Reynolds 3321 Cybersecurity Lab

Assessment of AV System, Viewing Distances, and Viewing Angles

Comments on Increasing the Number of Student Workstations

February 2, 2021

Existing Monitors: Horizontal Viewing Cone and Viewing Distance – Detailed Inspection Viewing Task

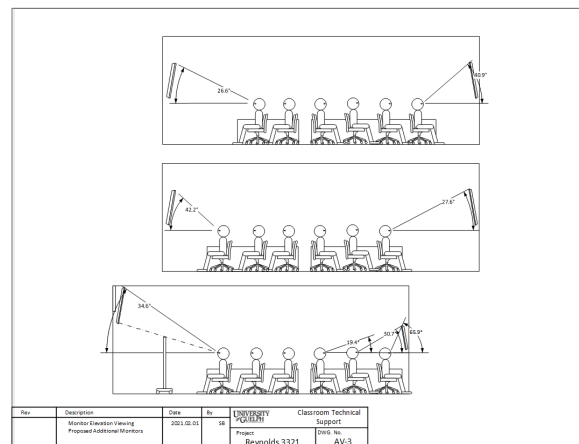
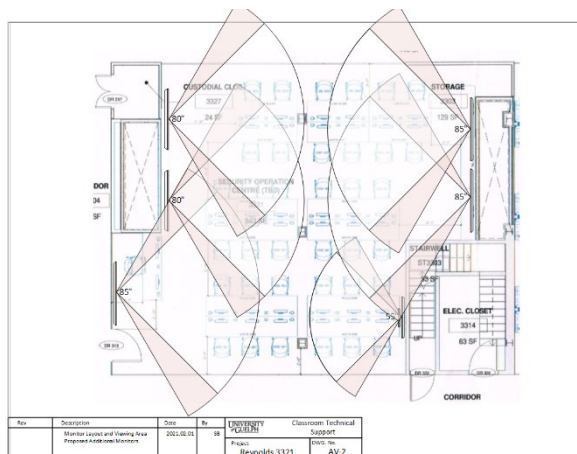
For several seats one of the monitors is located behind the student.

Most seats are beyond the maximum viewing distance.

New Monitors – All Showing the Same Image

Additional monitors can be added to the room so that as many of the students as possible:

- Have proper viewing distance for the detailed inspection viewing task,
- Are within the 90-degree viewing cone,
- Do not need to look behind to see a monitor.

This plan adds 3 – 85” monitors, and 1 – 55” monitor, for a total of 6 monitors. This layout is suitable for all monitors showing the same image. A new AV distribution system is needed to connect all the monitors. An AV control system is recommended for controlling the monitors and selecting the input to be distributed.

2 Monitors for Students

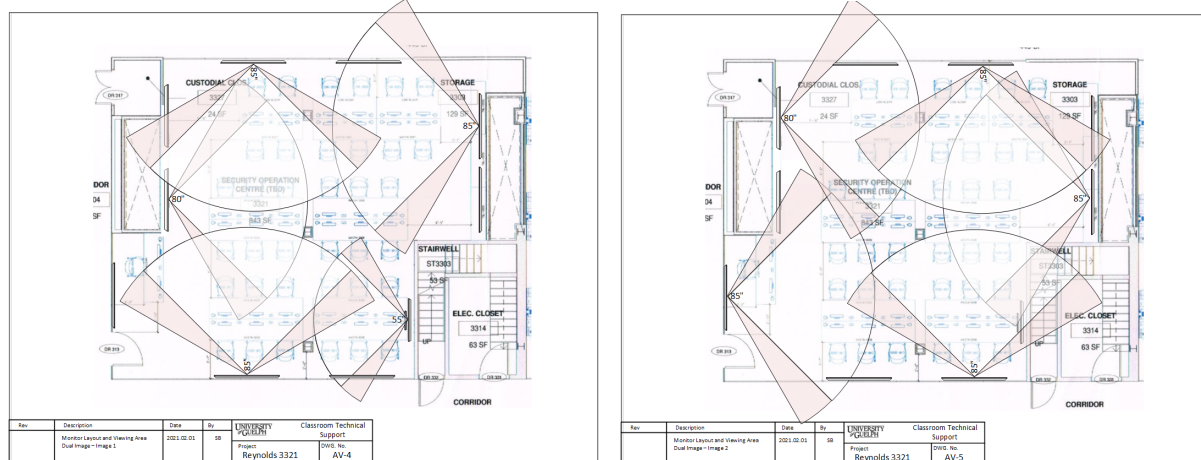
Currently the student workstations are 3' wide.

The monitors in the room are 21-3/4" wide.

Using 2 monitors plus a laptop to for course work requires a wider workstation. The 36-workstation count would need to be decreased by approximately 12 to accommodate 2 monitors and a laptop per station.

Two cohorts of 24 would make total enrollment 48 students.
